## Introduction

*This is a series of volumes which deal with specific TV receiver troubles and their cures. These trouble cures are the TV manufacturers' answers to some of the problems that may arise in their particular receivers.*

# TV

Fig. 1 — Admiral

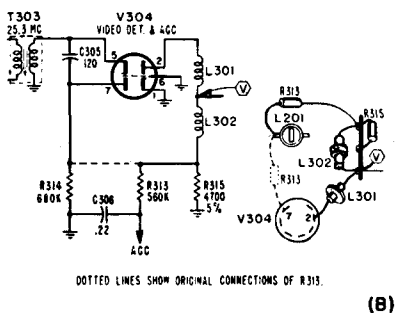
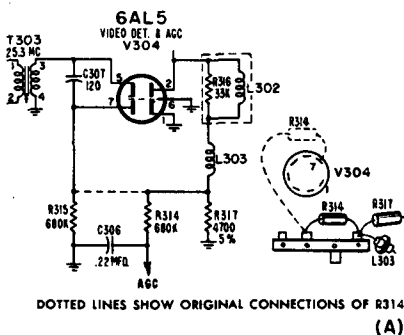
To make this change in chassis 20T1 and 20V1, disconnect the end of resistor R314 (680,000) from pin 7 of V304 and connect it to the terminal strip (junction of R317 and L303) as shown in part (A) of the figure.

To make this change in chassis 21B1 through 21E1, 21H1, 21J1, proceed as follows: Disconnect the end of R313 (560,000 ohms) from pin 7 of V304 and reconnect it to the terminal strip (junction of R315 and L302) as shown in part (B) of illustration.

Fig. 2 — Admiral

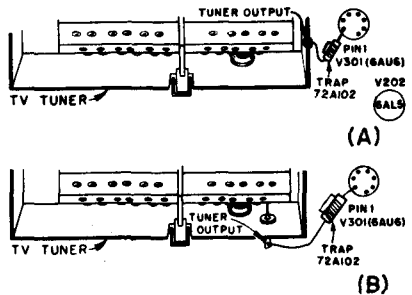
For chassis 20Z1, a trap, part No. 72A102, is available for removing such interference. This trap is fixed-tuned and consists of a coil and fixed capacitor resonant at 27.25 mc. The trap is connected by removing the lead between the r-f tuner and the grid (pin 1) of the first video amplifier V301 (6AU6) and connecting the trap in place of the lead. See part (A) of the figure for location. This trap may be installed in the field without realignment. Later production runs of the 20Z1 chassis will have the trap incorporated in production.

For chassis 21B1 and 21C1, a similar arrangement is used. See part (B) of the figure for location.

Fig. 4 — Admiral

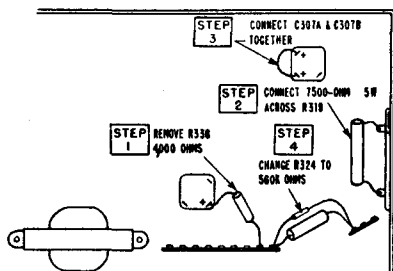
Blocking may occur if the tv set is tuned to a very strong tv signal which could drive the video amplifier to cut-off. With the video amplifier at cut-off, B+ voltage applied to the cathode of the picture tube will increase, thereby making the grid voltage more negative with respect to cathode, and driving the picture tube to cut-off. Also, since the gated agc tube is dependent upon voltage from the video amplifier for its operation, blocking of the video amplifier will prevent agc voltage from developing and the system will remain blocked.

1. Remove resistor *R336* (4,000 ohms).
2. Connect a 7,500-ohm, 5-watt resistor *R338* (part No. 61A1-18) across *R319*.
3. Connect together the positive terminals of filter capacitors *C307A* and *C307B*.
4. Change resistor *R324* from 180,000 ohms to 560,000 ohms, 1/2 watt (part No. 60B8-564).

Fig. 5 — Admiral

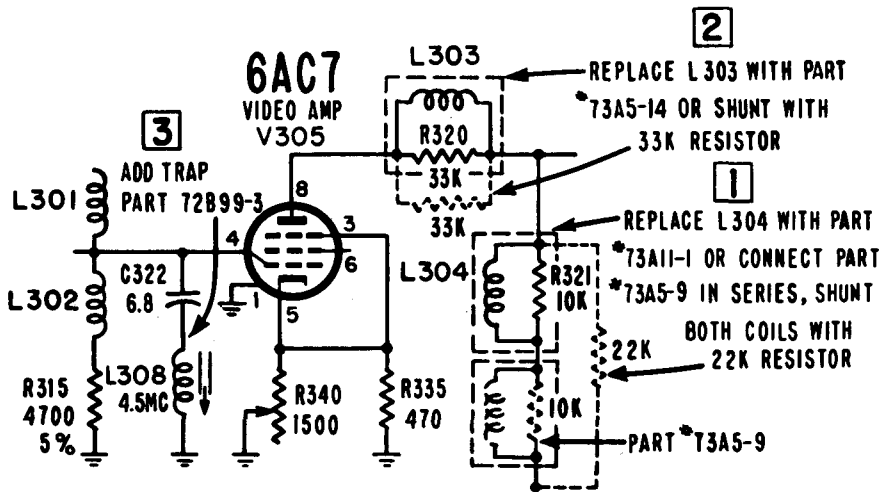
To reduce or eliminate 4.5-mc interference in the picture, the following is recommended. Note: Some later production sets may have this change incorporated.

1. Remove peaking coil *L304* (part No. 73A5-9) and replace it with peaking coil, part No. 73A11-1. Peaking coil 73A11-1 has a three pi winding. If part No. 73A11-1 is not available, use two 73A5-9 peaking coils connected in series, with short leads, so that the coils are not more than  $\frac{3}{4}$  inch apart. Connect a 22,000-ohm,  $\frac{1}{2}$ -watt resistor (part No. 60B8-223) across this two-coil assembly.

2. Remove peaking coil *L303* (part No. 73A5-13) and replace it with peaking coil, part No. 73A5-14. Peaking coil 73A5-14 is coded with a blue dot. If part No. 73A5-14 is not available, part No. 73A5-13 should be left in the receiver and a 33,000-ohm,  $\frac{1}{2}$ -watt resistor (part No. 60B8-333) should be wired across it.

Fig. 6 — Admiral

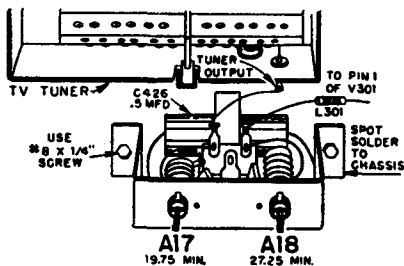
Two adjacent-channel traps *L309* (27.25 mc) and *L310* (19.75 mc) may be added between the output of the tv tuner and the input of the first video i-f amplifier *V301* (6AU6). This is done to eliminate the possibility of interference from the video carrier of the adjacent channel above, and the sound carrier of the adjacent channel below, the desired channel.

The 19.75-mc trap will remove adjacent-channel video interference, and the 27.25-mc trap will remove adjacent-channel sound interference.

Fig. 7 — Air King

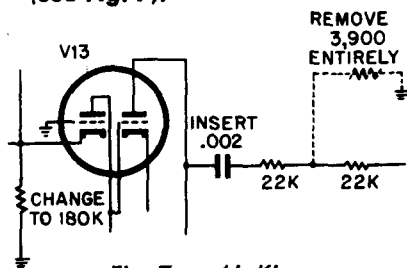
To increase vertical sync stability a .002- $\mu$ f capacitor should be inserted between the 22,000-ohm resistor and plate (pin 1) of the sync amplifier and phase splitting tube (V-13) as shown in the drawing. In conjunction with this change the 3,900-ohm resistor from the junction of the 22,000-ohm resistor to ground should be removed.

To further improve vertical sync stability in strong signal areas, change the 270,000-ohm cathode resistor of V-13 to 180,000 ohms. These changes are now being incorporated in later production runs.

Fig. 8 — Andrea

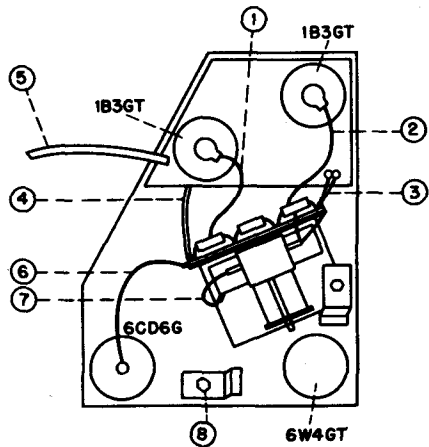
Whenever any work must be done in the high-voltage compartment or if a tube is replaced in this section, proper lead dress must be maintained. Extreme care must be used to prevent connecting wires to the tube caps from touching any portion of the metal compartment or other components. Failure to observe this precaution may cause arcing and burning.

Wires 1, 2, 5, 6, and 7 shown in the figure must be kept in the clear. They must not rest on other components or on the sides of the compartment. Whenever parts are replaced, make these wires short and direct but do not put a strain on the parts. Wires 3 and 4 must not be pulled too tightly. Be sure to round off soldering connections on any work done. Also, do not turn the width coil slug (part 8 in the figure) out too far, thereby lowering the impedance, as this may cause the coil to overheat or even burn.

Fig. 9 — Arvin

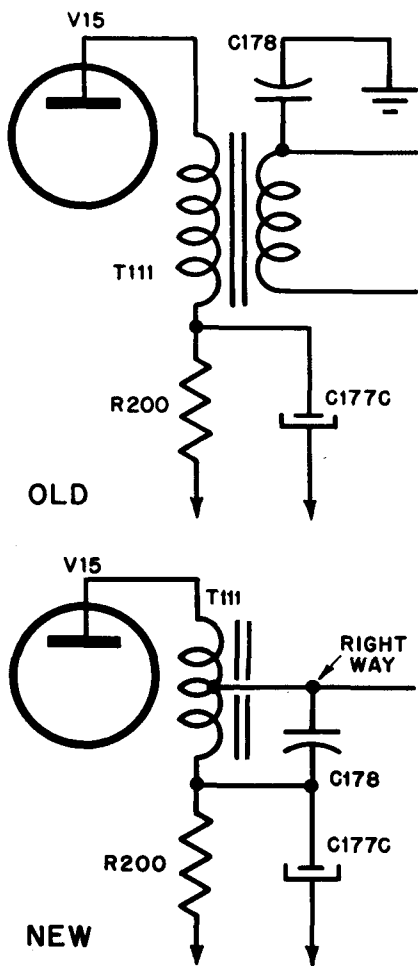
In later models, the vertical-output transformer, *T111*, was changed to an autotransformer having three leads instead of four. If *C178* is left with one side hooked to ground, vertical buzz will be present in the speaker. In those receivers in which this fault exists, *C178* should be connected to the junction of *R200* and *C177C* instead of ground. This is shown in the figure.

Fig. 10 — Arvin

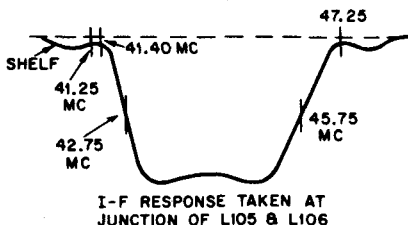
1. Check buzz due to intermodulation within the sync and audio tube, *V19*, by pulling out *V1*, 6AU6. Change *V19* if buzz is still audible.

Fig. 11 — Arvin

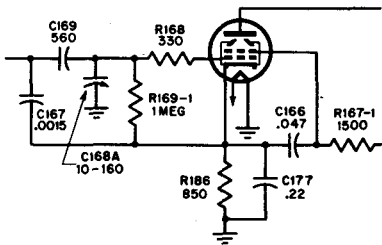
The life of V12 can be increased by making this change:

1. R186 850-ohm, 10-watt resistor added between cathode and ground of 6AV5GT tube.
2. Ground side of C166 capacitor rerouted to cathode of 6AV5GT.

3. *C177*, .22- $\mu$ f, 400-volt capacitor added to cathode circuit of 6AV5GT tube.

Fig. 14 — Bendix

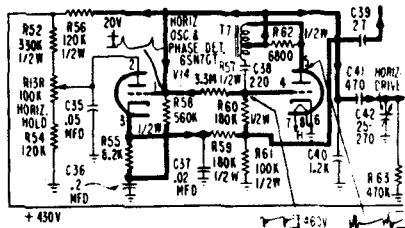
tate easier mechanical adjustment of the focus coil, a revision of the horizontal oscillator and phase-detector circuit may be made as shown in the figure.

1. Remove lead of capacitor C39 from the junction of capacitors C40 and C41.

Fig. 16 — Capehart-Farnsworth

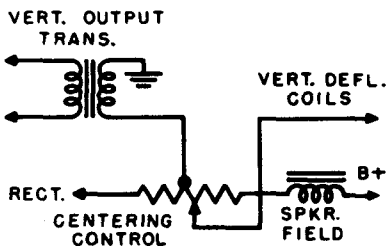
A vertical-centering control may be installed by performing the following operations. The control is a 10-ohm, 2-watt center-tapped potentiometer, part No. 450662A-1. It should be installed in some convenient location on the rear chassis apron.

1. Connect the control in series with the speaker field coil (filter choke), using the end terminals of the control.
2. Open the vertical output transformer yoke lead.
3. Connect the transformer lead to the fixed center tap on the control.
4. Connect the yoke lead to the variable arm on the control.

Fig. 20 — Capehart-Farnsworth

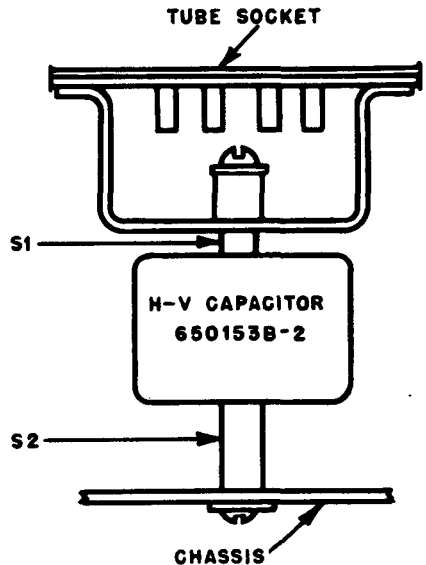
This is the 500- $\mu\mu\text{f}$ , 200,000-volt high-voltage filter capacitor, part No. 650153B-2.

Fig. 21 — Capehart-Farnsworth

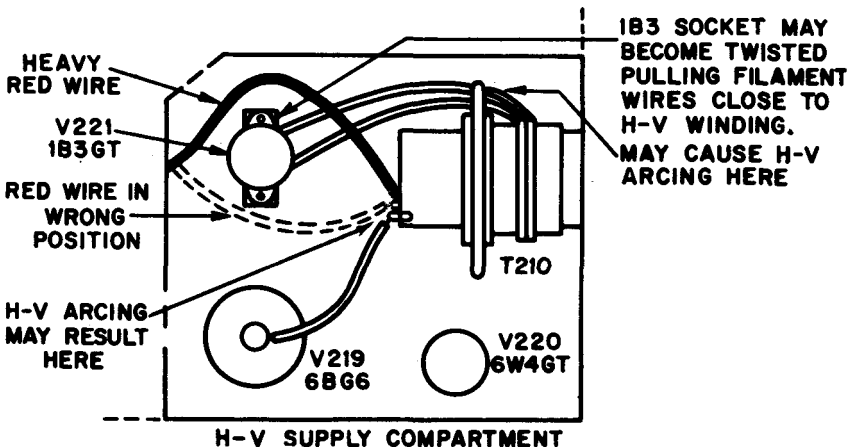
If necessary to replace the 1B3 rectifier tube in h-v section of the receiver, it is possible, if care is not exercised, to disarrange the wiring. This might cause high-voltage arcing or a short to develop resulting in a burned-out transformer. Note carefully in the sketch the proper position of the 1B3 socket, so as to avoid drawing the filament-supply leads against the transformer coil. Also note correct position of the heavy red wire between the horizontal-output transformer and the deflection yoke.

It must be between the 1B3 tube and power-supply shield — not between the 1B3 and 6BG6 tubes.

Fig. 23 — Capehart-Farnsworth

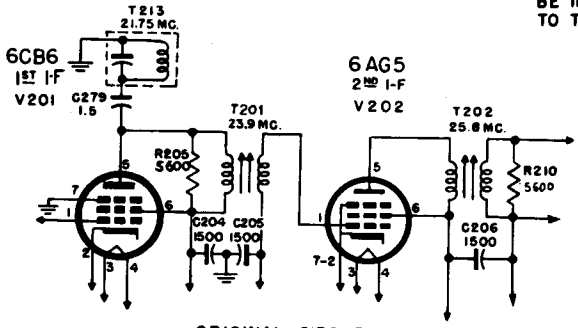
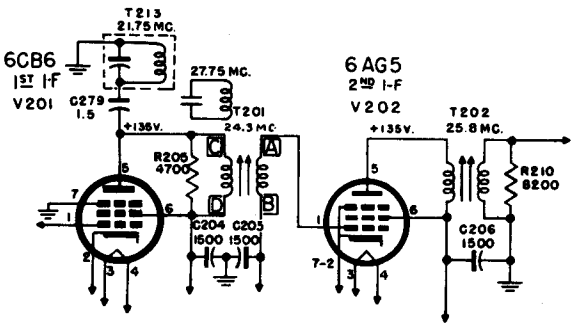
trap and replaces the original first i-f transformer.

Fig. 24 — Capehart-Farnsworth

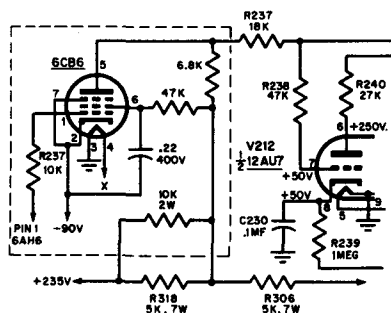
It is possible, under particularly severe conditions, that greater range of the contrast control may be required without loss of sync. If so, a

6CB6 sync-amplifier tube may be easily installed on the chassis between the 6AL5 (*V204*) and 12AU7 (*V212*). Using a socket punch, cut a 5/8-inch hole in the chassis. Install socket and wire as shown in the figure.

Fig. 25 — Capehart-Farnsworth

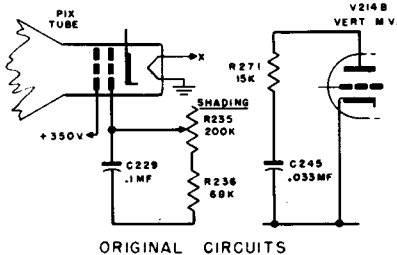
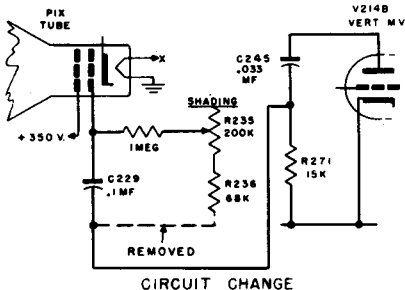
### Blanking of vertical-retrace lines (see Fig. 25).

Fig. 26 — Capehart-Farnsworth

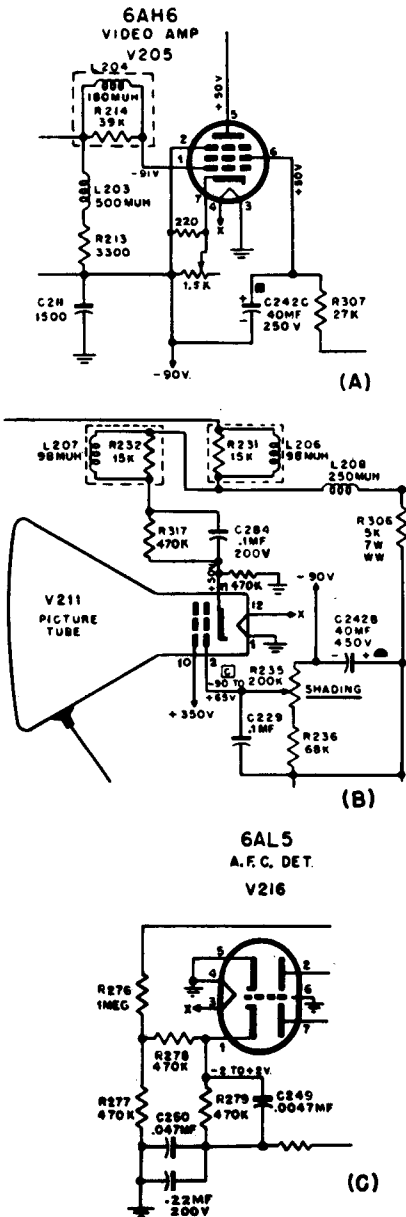
A condition of vertical linearity instability evidenced by a cyclic, or

repetitive, expansion and contraction in the vertical direction of a portion of the picture can be corrected by the following circuit change. Remove the center arm of the *Height Control* (R273) from +310 volts and connect to the junction of R266 and C243A. Remove R266 from +310 volts and connect to +295 volts. All connections are in a convenient position and it should take only a few seconds to change the two wires involved.

Fig. 27 — Capehart-Farnsworth

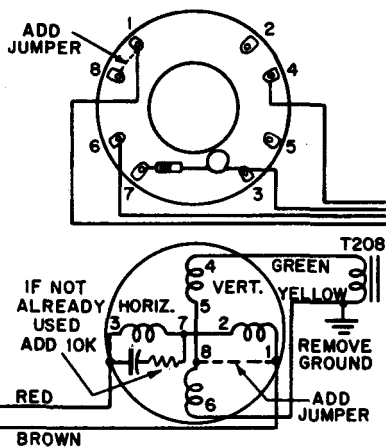
Some high-voltage breakdowns between yoke windings have been reported in yokes 750192A and B which are furnished with models 335 and 337 (with the above chassis). To reduce the potential difference between windings, the following change procedure should be followed:

1. Remove the chassis.

**Fig. 29 — Crosley**

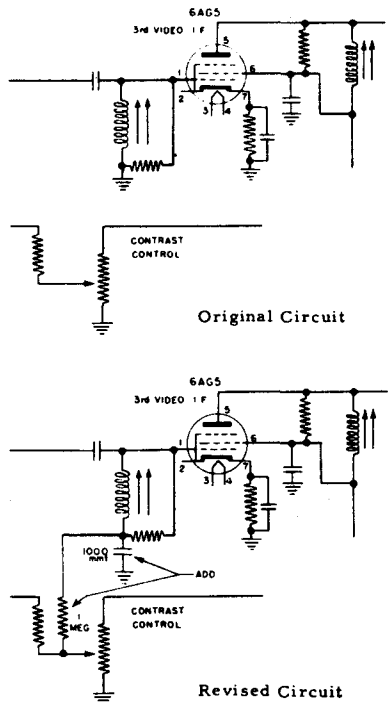
In some cases where these sets are operated in areas where the signals from one or more stations is exceptionally strong it may cause the contrast control to operate very critically. This condition can be corrected without losing sensitivity in the re-

ceiver by adding a variable bias to the third picture i-f stage. This can be accomplished by making the following wiring changes:

Fig. 30 — Crosley

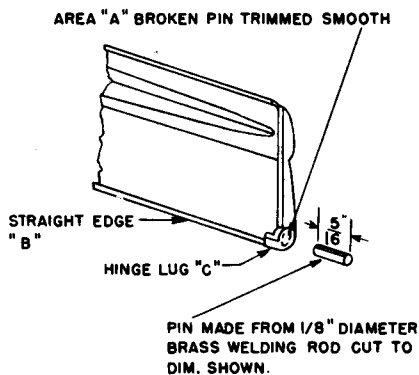
When a broken hinge pin is encountered on the doors, repairs can easily be made in the following manner:

Fig. 31 — Crosley

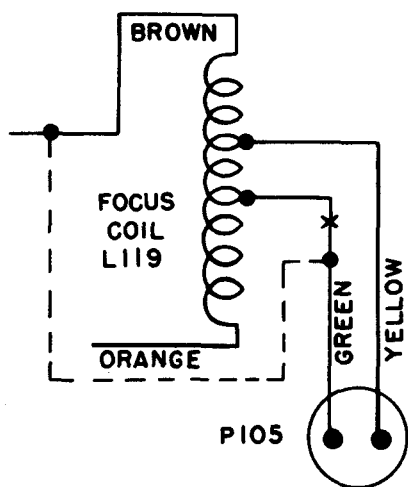
If it becomes necessary to increase the range of the *Focus Control* on the 20- or 21-inch models of 1952, connect the focus coil (*L119*) as shown in sketch and explained below.

1. Cut the green wire at X and tape the bare end of the portion of wire that remains on the focus coil. Be sure to allow enough wire to remain on the coil, just in case it is ever necessary to reconnect it in its original manner, if for any reason the picture tube must be replaced at a later date.

Fig. 32 — Crosley

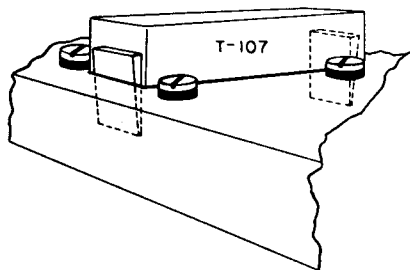
Horizontal-sweep sing can be caused by vibration of the mounting bracket on the horizontal-output transformer, *T107*. This mounting

Fig. 35 — Crosley

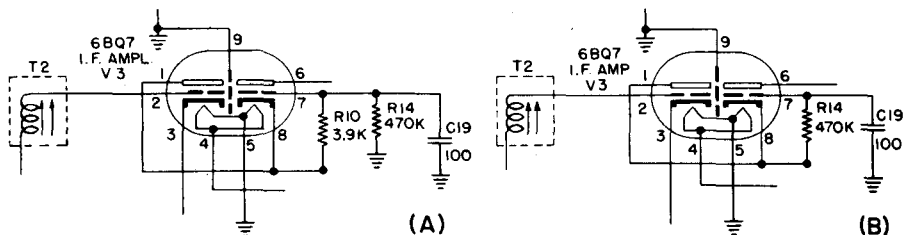
Early production sets were wired according to schematic (A) shown in the figure. To increase the sensitivity on later production sets the

Fig. 40 — DuMont

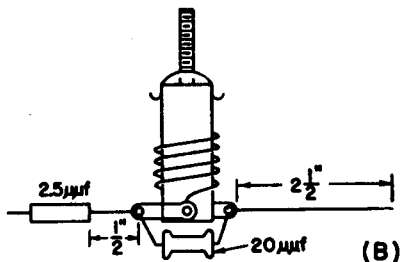
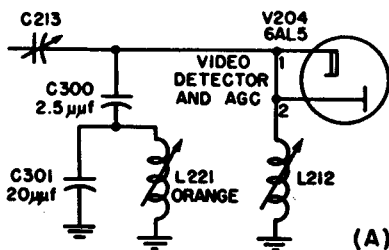
**Adjacent-channel interference (see Fig. 40).**

Fig. 49 — DuMont

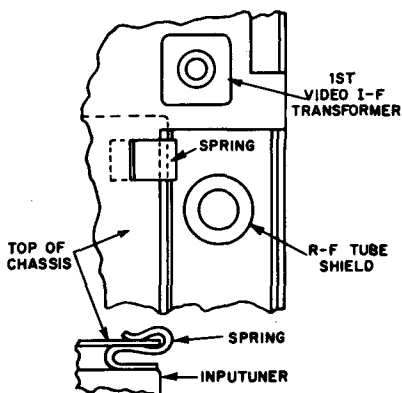
To reduce regeneration, a grounding spring (part No. 30015401) should be inserted between the *Inputuner* and the chassis as shown in the illustration.
